SUBJECT: ORGANIZATION FOR CONDUCT OF PLANT OPERATIONS WHILE IN COLD SHUTDOWN
CONDITION (TAC NO. 65680)

RE: PEACH BOTTOM ATOMIC POWER STATION, UNIT NOS. 2 AND 3

AMENDMENT TO FACILITY OPERATING LICENSE

SAFETY EVALUATION BY THE OFFICE OF NUCLEAR REACTOR REGULATION SUPPORTING

FIGURE 6.2-2
ORGANIZATION FOR CONDUCT OF PLANT OPERATIONS
PEACH BOTTOM ATOMIC POWER STATION

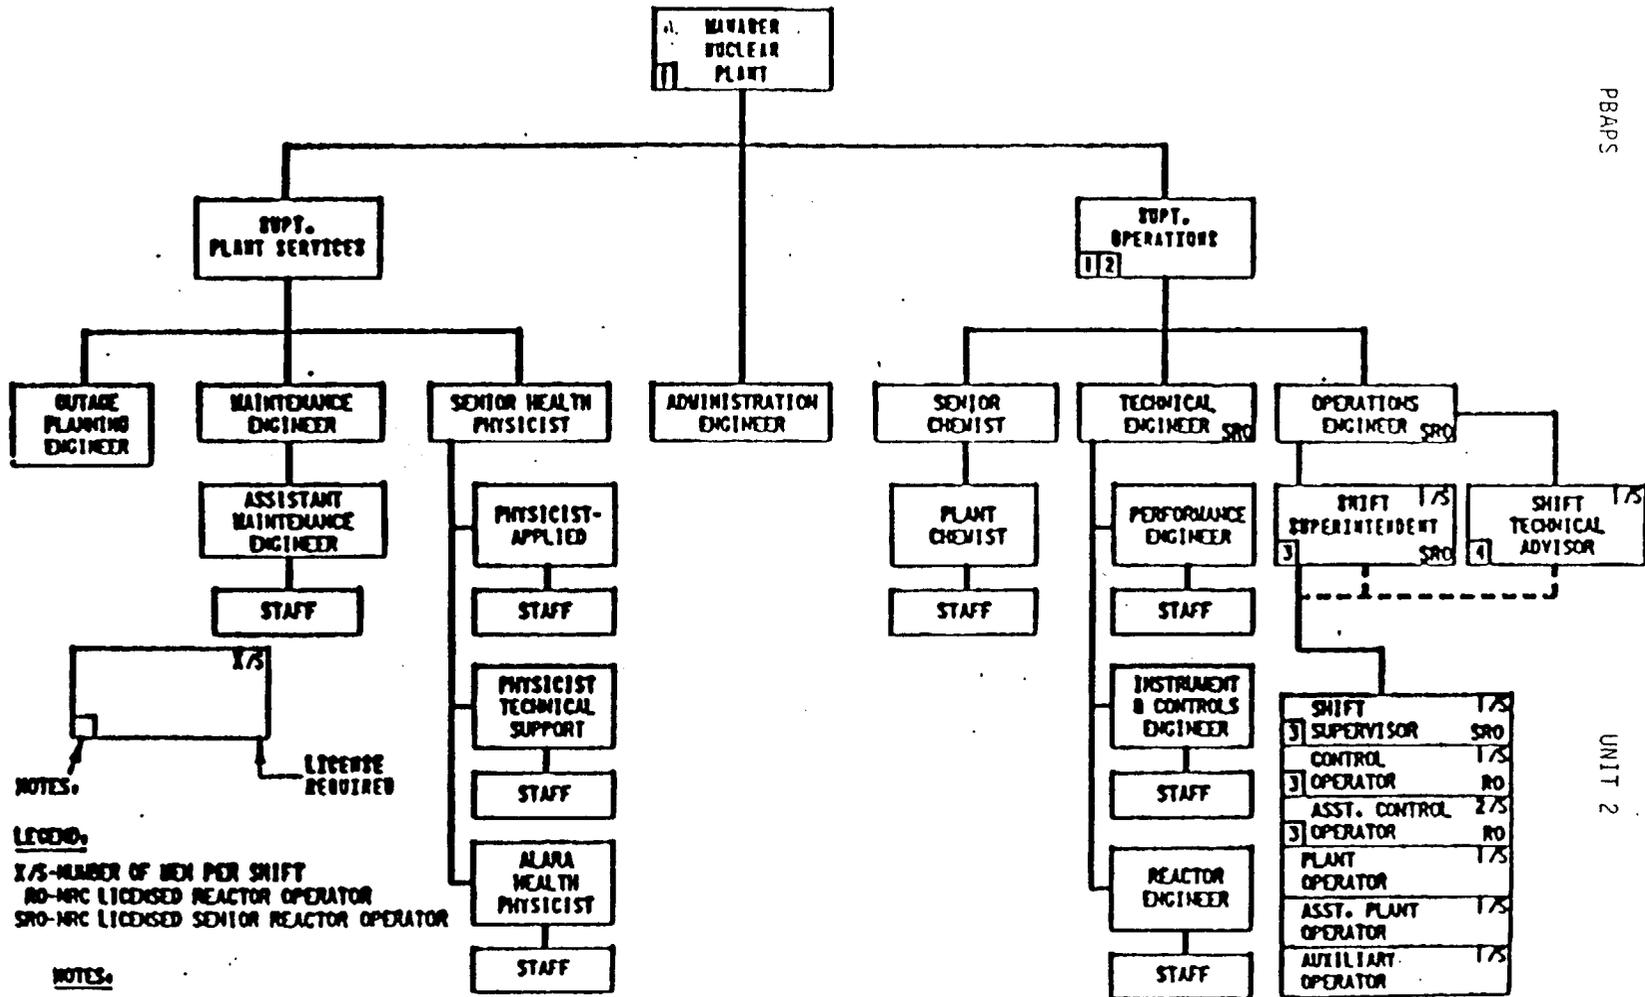
*Except during cold condition operations resulting from the NRC shutdown order of March 31, 1987.

FIGURE 6.2-2
ORGANIZATION FOR CONDUCT OF PLANT OPERATIONS
PEACH BOTTOM ATOMIC POWER STATION

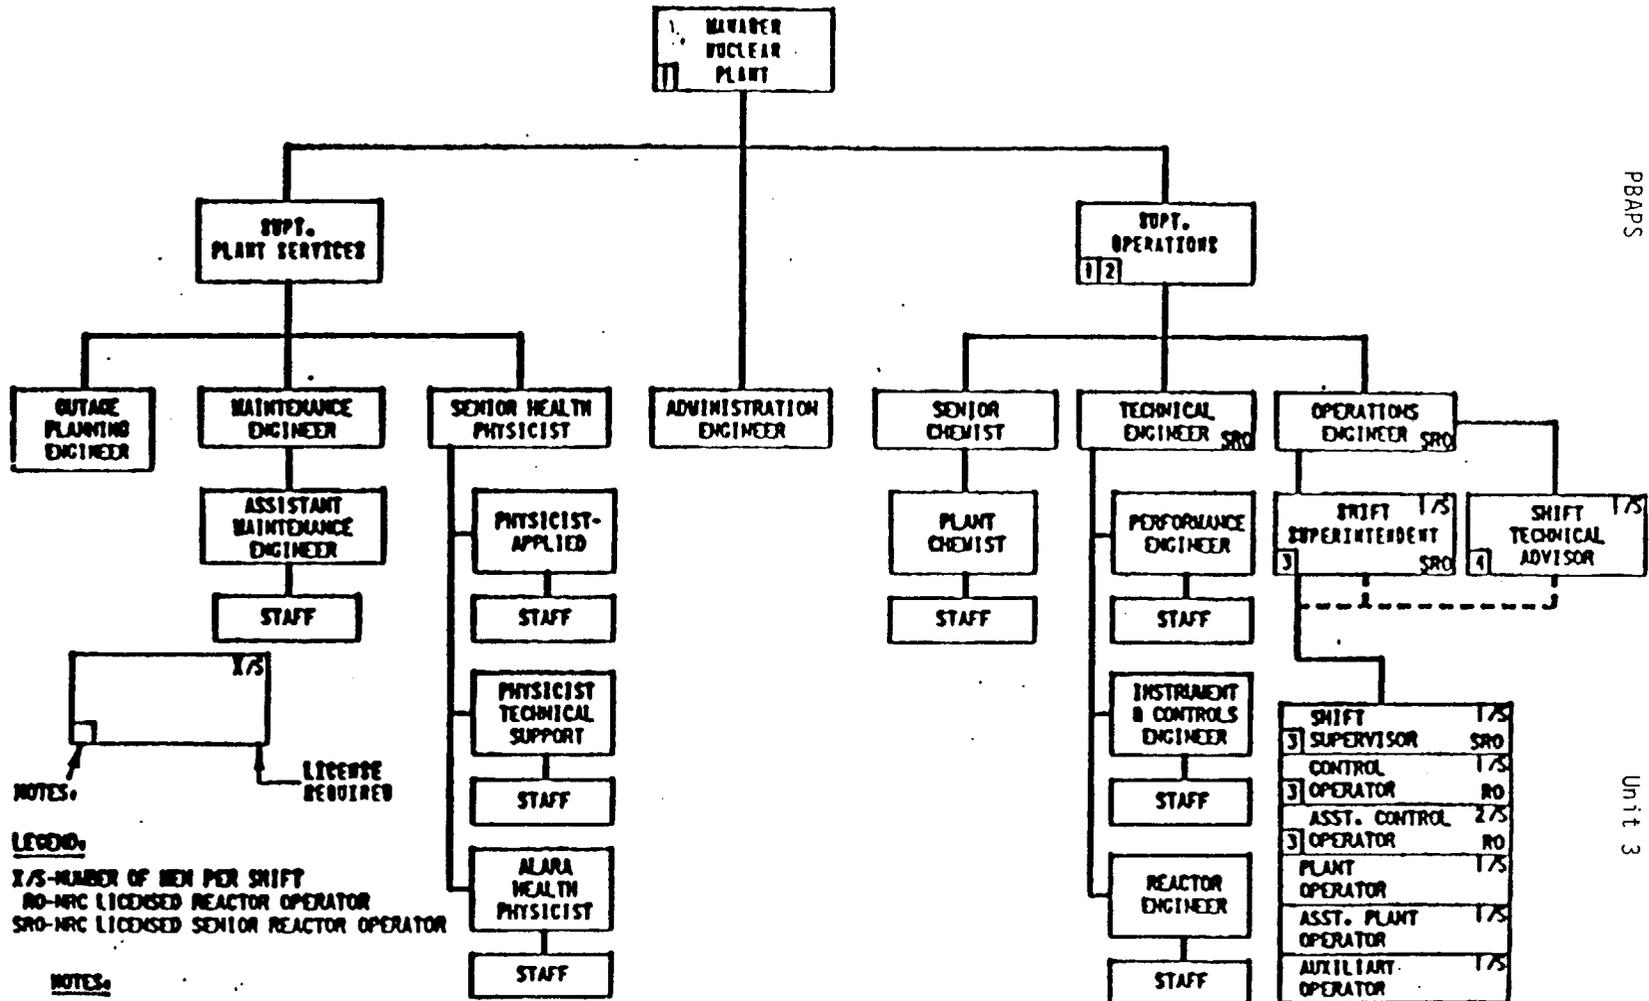
*Except during cold condition operations resulting from the NRC shutdown order of March 31, 1987.
